PIC12F508/509 Rev. A Silicon/Data Sheet Errata

The PIC12F508/509 parts you have received conform functionally to the Device Data Sheet (DS41236C), except for the anomalies described below.

FIGURE 1:

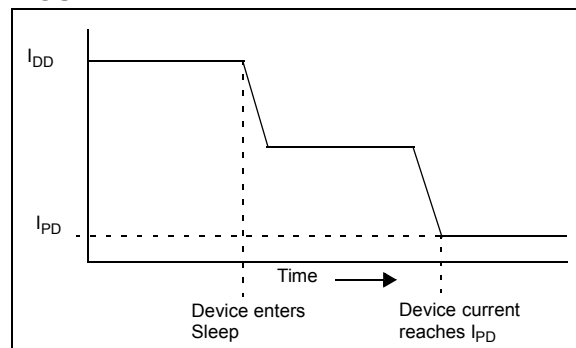
On the PIC12F508/509 silicon, revisions earlier than A3, the power-down base current may remain higher than the specification for a short time when entering Sleep.

The following graph illustrates the device current upon entering Sleep:

The length of time between the device entering Sleep mode and the device current reaching I_{PD} increases as both temperature and voltage decrease.

This issue is fixed in Revisions A3 and later.
